UNITED STATES PATENT AND TRADEMARK OFFICE

Office Action Summary

10/627,810

Renee S. Luebke

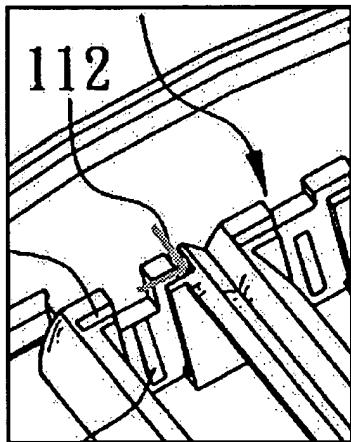
5. Claims 1, 2 and 4-7 are rejected under 35 U.S.C. 102(b) as being anticipated by Applicant’s cited prior art (Figs. 1, 5A and 5B, and page 2 of the disclosure). This device comprises first openings at the tops of the grooves 10,

a second opening through the outer case (not shown), a well including the grooves, and a seat at each end of each groove. The grooves each are proportioned “so that a plurality of cells can be installed” as claimed. The first seat includes a first indentation 110, an inclined protrusion 111 and an L-shaped hole 112 (as marked in the copy of fig. 1 at left). When held vertically, this L-shaped recess has a vertical hole and a
